SAFETY EVALUATION BY THE OFFICE OF NUCLEAR REACTOR REGULATION

TENNESSEE VALLEY AUTHORITY

BROWNS FERRY NUCLEAR POWER PLANT, UNITS 1, 2 AND 3

DOCKET NOS. 50-259, 50-260, and 50-296

Figure 1. General graph of a fast transient/burst.

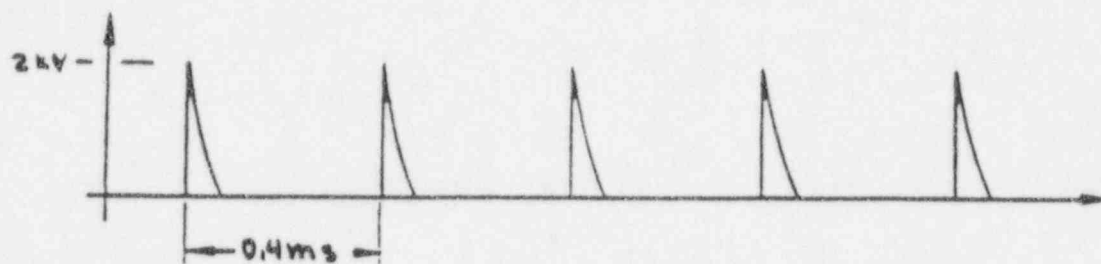
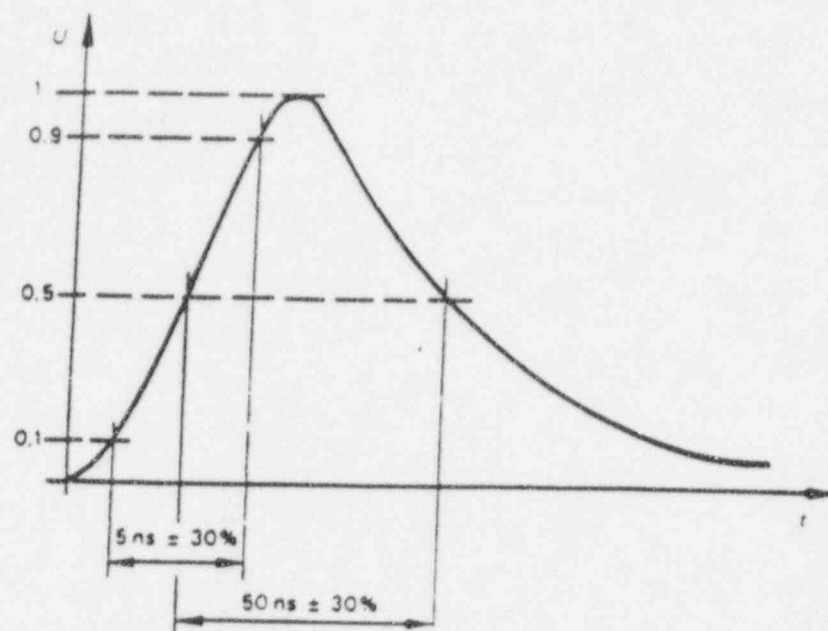
The technical justification in the NTS report is that the fast transient/burst test signals contain a signal spectrum of all frequencies, and the input impedance of the equipment under the test is constant. Therefore, NTS concludes an FT of the transient/burst test signals can be performed. NTS used an FT to convert the test signals for the IEC 801-4 test method from time domain to frequency domain. To perform an FT, the NTS report assumed that:

1. the fast transient/burst test signals are periodic (see Figure 1, attached),
2. the fast transient/burst signals generated for the test are the same and are without any variations and distortions, and
3. all spectra of fast transient/burst test signals were coupled onto the RBVRM power line without any attenuation throughout all frequency ranges.

Based on the above analysis, the staff disagrees with the NTS assumptions for converting the time domain voltage signal into the frequency domain current signal, and finds NTS's Fourier Analysis not acceptable. The staff's findings are consistent with current industry electromagnetic capability
